ARCHITECTURAL REVIEW BOARD STAFF REPORT

Project #/Name	ARB-2022-08: RST Residences – Final
Review Type	Final Site Plan and Architectural Review
Parcel Identification	04600-00-00-10800, 04600-00-00-10900
Location	East side of Rt. 29, north of Ashwood Blvd. (See Figures 1 and 2.)
Zoned	Planned Residential Development (PRD) / Entrance Corridor (EC)
Owner/Applicant	Seminole Trail LLC C/O RST Development, LLC / Bohler (Ryan Yauger)
Magisterial District	Rivanna
Proposal	To construct a residential development with approximately 254 apartments in 4 buildings and 78 townhouses in 6 blocks, with associated site improvements.
Context	The property is currently occupied by a motel and the Ridgewood mobile home community. The Forest Lakes neighborhood, with a mix of single-family attached and detached dwellings, is located to the east and southeast. The Brookhill development is located to the south across Ashwood Blvd. Forested properties are to the west across U.S. Route 29 and to the north.

ARB Meeting Date	March 21, 2022
Staff Contact	Khris Taggart

Figure 6: Proposed site layout.

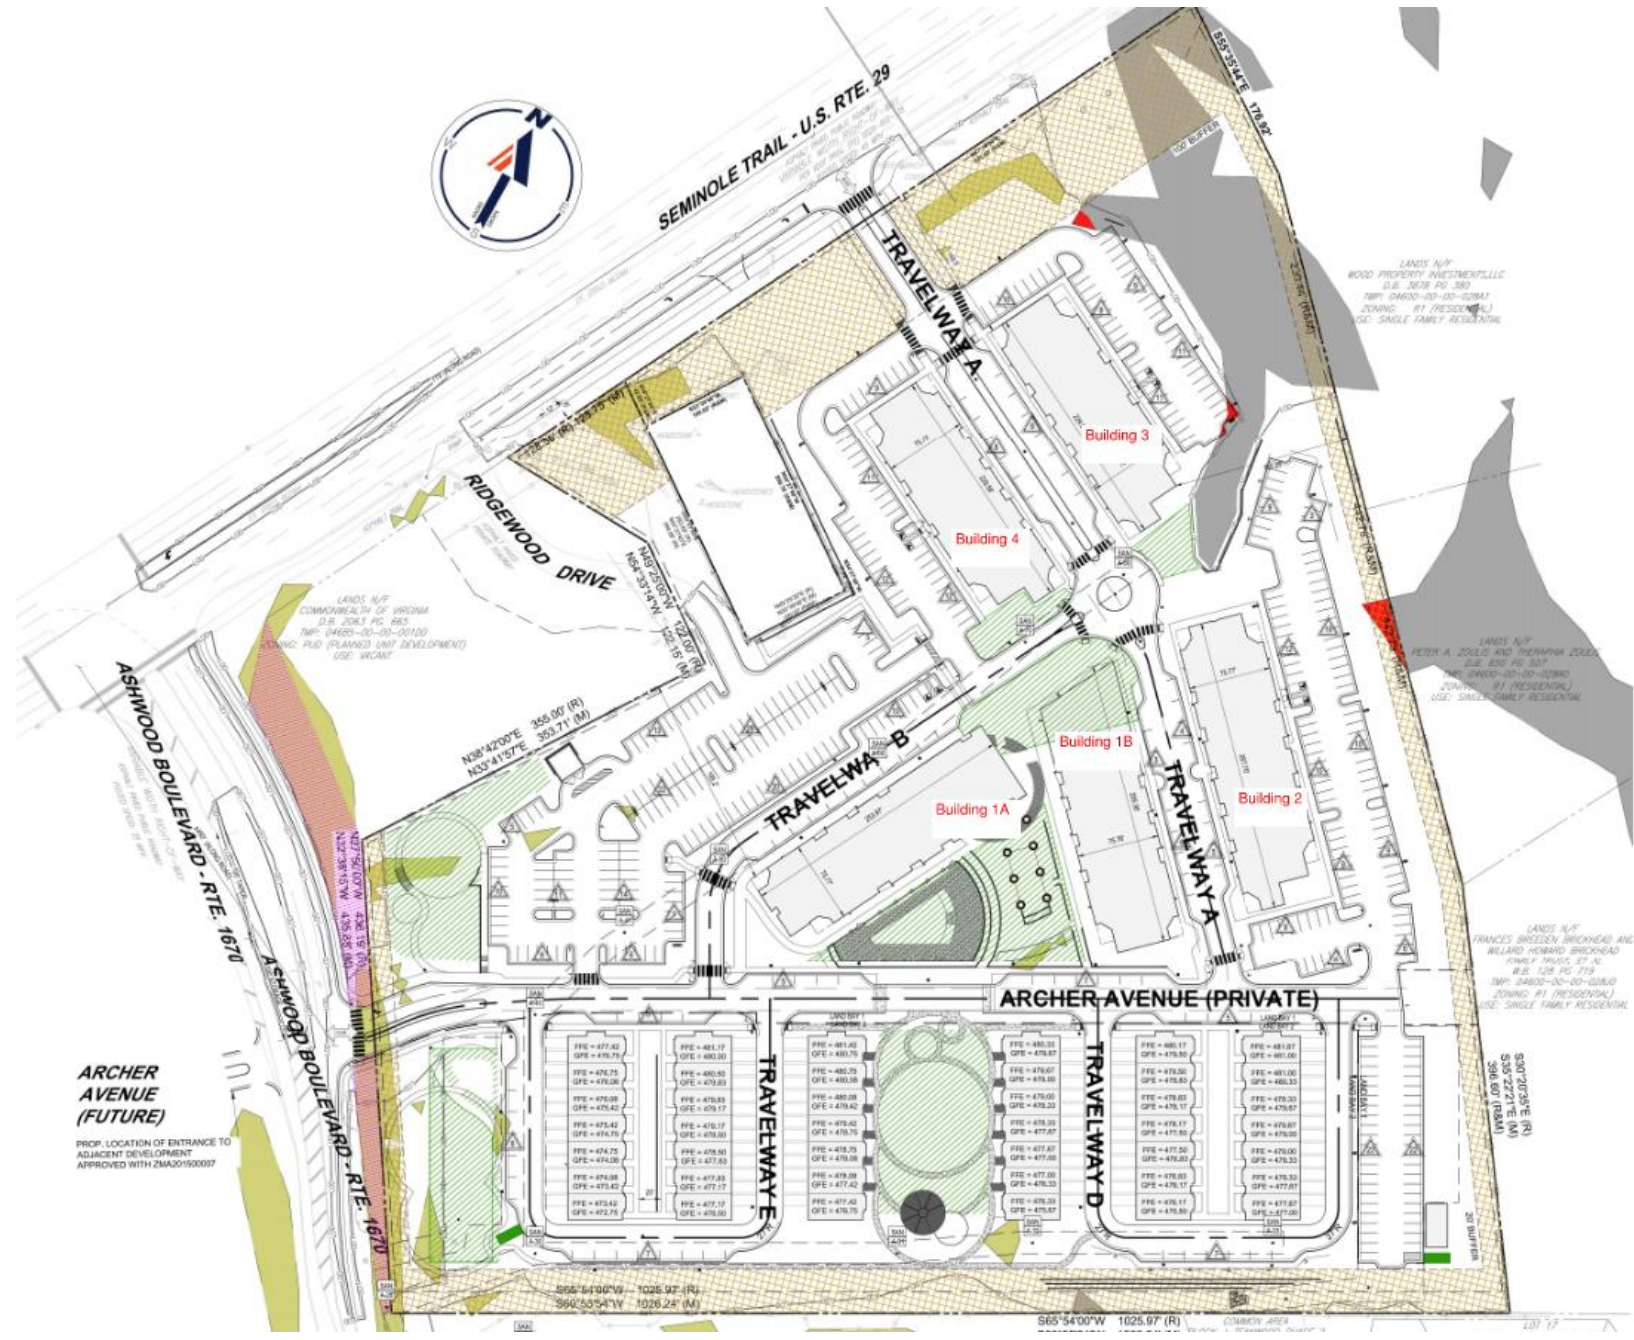
Accessory structures and equipment			
17	Accessory structures and equipment should be integrated into the overall plan of development and shall, to the extent possible, be compatible with the building designs used on the site.	None.	The site plan has been revised to show a dumpster enclosure along the western perimeter of the large parking lot south of Building 4. The detail in the plan notes that the enclosure will be a warm dark brown brick to match the one used in the apartment building. However, in this location the enclosure is reliant on existing offsite vegetation on the adjacent VDOT parcel to the west to provide screening. Revising the landscape plan to show shrubs along west side of the enclosure, 24” at time of planting, would be appropriate. A detail for the cemetery fence has been provided. The detail notes aluminum ornamental fencing in black which is expected to have an appropriate appearance.	See recommendation at #36.

33	Landscaping along interior roads: a. Large trees should be planted parallel to all interior roads. Such trees should be at least 2½ inches caliper (measured six inches above the ground) and should be of a plant species common to the area. Such trees should be located at least every 40 feet on center.	Consider adding trees along Travelway B and Private Road C.	The site plan has been revised to provide trees, in regular intervals, along Travelway B and Archer Avenue (Private Road C).	None.
34	Landscaping along interior pedestrian ways: a. Medium trees should be planted parallel to all interior pedestrian ways. Such trees should be at least 2½ inches caliper (measured six inches above the ground) and should be of a species common to the area. Such trees should be located at least every 25 feet on center.			
35	Landscaping of parking areas: a. Large trees should align the perimeter of parking areas, located 40 feet on center. Trees should be planted in the interior of parking areas at the rate of one tree for every 10 parking spaces provided and should be evenly distributed throughout the interior of the parking area. b. Trees required by the preceding paragraph should measure 2½ inches caliper (measured six inches above the ground); should be evenly spaced; and should be of a species common to the area. Such trees should be planted in planters or medians sufficiently large to maintain the health of the tree and shall be protected by curbing. c. Shrubs should be provided as necessary to minimize the parking area’s impact on Entrance Corridor streets. Shrubs should measure 24 inches in height.	Add perimeter trees (2½” caliper, 40’ on center) along the east, west and south sides of the large parking lot. Increase the planting size of interior parking lot trees to 2½” caliper.	Perimeter parking trees have been added along the east, west, and south sides of the large parking lot. However, these trees and the interior parking area trees are still smaller than the 2½” caliper requirement. Additionally, the parking lot relies on existing offsite vegetation on the adjacent VDOT parcel to the south and west to provide screening. Revising the landscape plan to show shrubs along the south and west sides of the large parking lot would be appropriate to minimize the parking area’s impact on the EC in the event that the existing vegetation on the VDOT parcel is cleared.	Increase the planting size of the exterior and interior parking lot trees to 2½” caliper. Revise the landscape plan to show shrubs, 24” at time of planting, along the south and west sides of the large parking lot.

36	Landscaping of buildings and other structures: a. Trees or other vegetation should be planted along the front of long buildings as necessary to soften the appearance of exterior walls. The spacing, size, and type of such trees or vegetation should be determined by the length, height, and blankness of such walls. b. Shrubs should be used to integrate the site, buildings, and other structures; dumpsters, accessory buildings and structures; “drive thru” windows; service areas; and signs. Shrubs should measure at least 24 inches in height.	Consider adding trees along the west elevation of Building 1.	Three trees have been added along the west elevation of Building 1 near the intersection of Travelway A and B, but trees have not been provided along the full extent of Building 1. The site plan has been revised to show a dumpster enclosure along the western perimeter of the large parking lot south of Building 4. The detail in the plan notes that the enclosure will be a warm dark brown brick to match the one used in the apartment building. However, in this location the enclosure is reliant on existing offsite vegetation on the adjacent VDOT parcel to the west to provide screening. Revising the landscape plan to show shrubs along the west side of the enclosure, 24” at time of planting, would be appropriate.	Revise the landscape plan to show shrubs, 24” at time of planting, along the west side of the dumpster enclosure.

11. Increase the planting size of the exterior and interior parking lot trees to 2½" caliper.
12. Revise the landscape plan to show shrubs, 24" at time of planting, along the south and west sides of the large parking lot.

13. Revise the landscape plan to show shrubs, 24" at time of planting, along the west side of the dumpster enclosure.
14. Show tree protection fencing on, and coordinated throughout, the grading, landscaping, and erosion and sediment control plans.
